Our Ref: 11584\_Letter - Amended Layout

**RE: DA22/0318 – Amending Lot Layout**

Property: 158-164 Old Bathurst Road, Emu Plains

**Figure 1** Former Proposal - Section of Road MC01 deflection angle of 78 degrees and radius of 23m

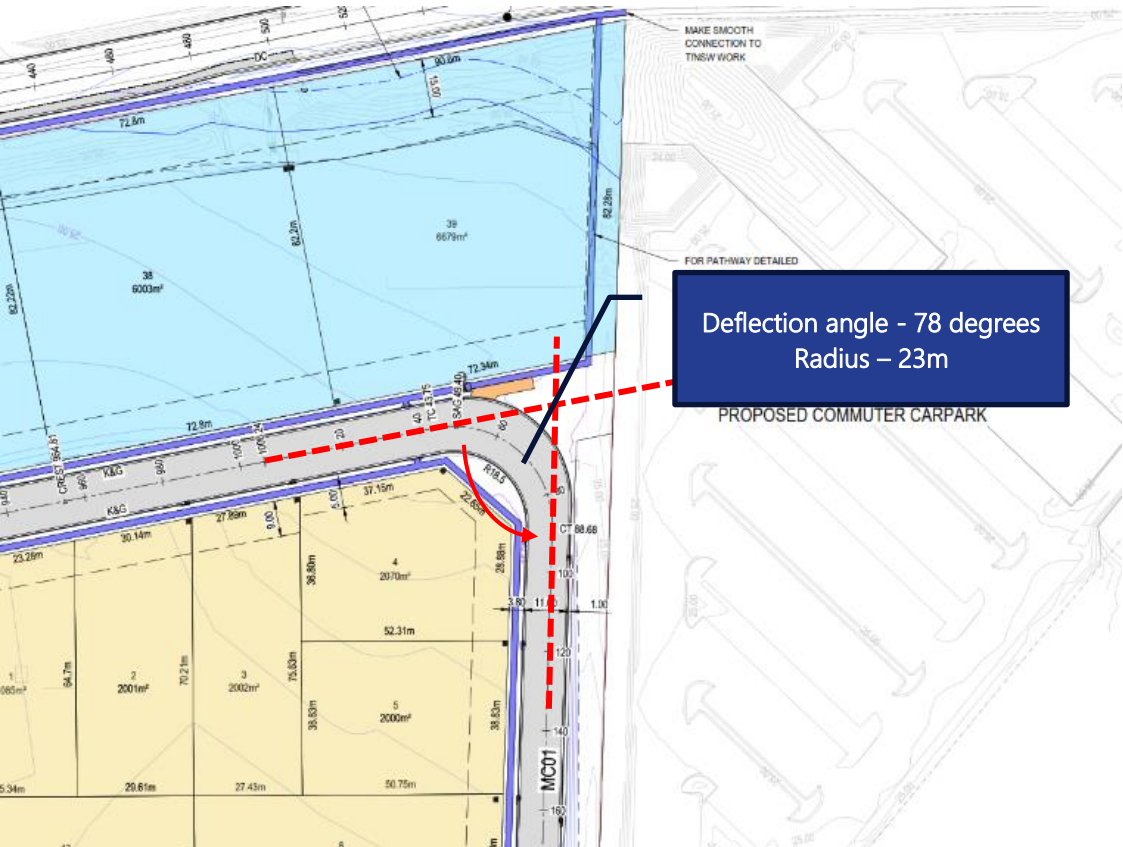
The Applicant has provided evidence that the Former Proposal complies with the above, with the portion of Road MC01 having a deflection angle of 78° and a radius of 23m. Further, swept path diagrams demonstrate that two B-Double Semi Trailers could pass each other on the corner in question (see **Figure 1 and 2**).

Despite the provision of additional evidence from the Applicant, Council has stated that its interpretation of Section 2.2.13 of Council’s *Design Guidelines for Engineering Works for Subdivision and Development* is that roads with a deflection angle more acute than 90 degrees are not permitted. Despite our disagreement, the Applicant has agreed to amend the road alignment as shown in **Figure 3** in the hope that this will enable the final determination of the application.

### Figure 3 Amended Road MC01 Configuration

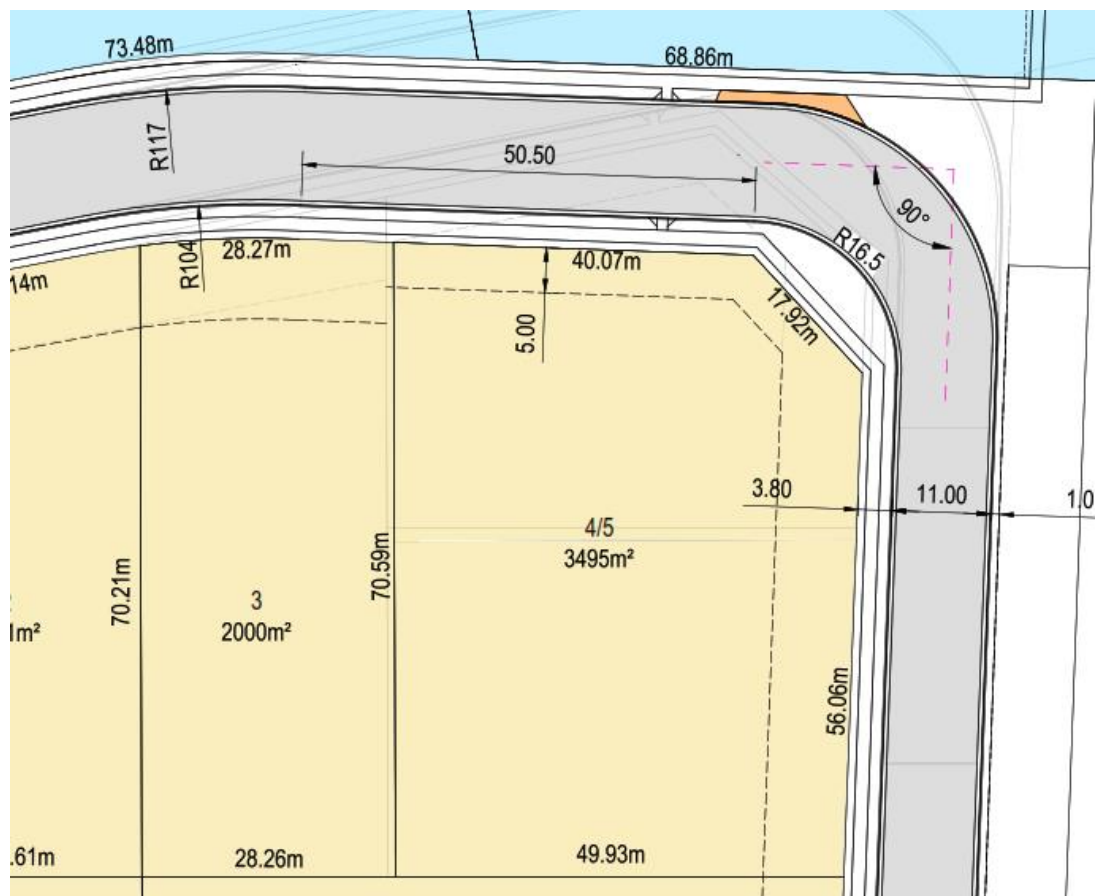
The amendment road alignment has resulted in changes to lot areas as described in **Table 1**.

Lot	Former Proposal	Amended Proposal	Comment
Lot 3	2,002m <sup>2</sup>	2000m <sup>2</sup>	
Lot 4	2,070m <sup>2</sup>	3954m <sup>2</sup>	Realignment of road has meant for Lot 4 to maintain compliance with the minimum Lot size, Lot 4 and Lot 5 need to be amalgamated.
Lot 5	2,000m <sup>2</sup>	N/A	Area amalgamated into Lot 4. Lot numbers have been adjusted accordingly.
Lot 38/39	6,679m <sup>2</sup>	7,559m <sup>2</sup>	Former Proposal Lot 39 has been renumbered to Lot 38. The realignment of the road has allowed for additional area to be attributed to Lot 38.
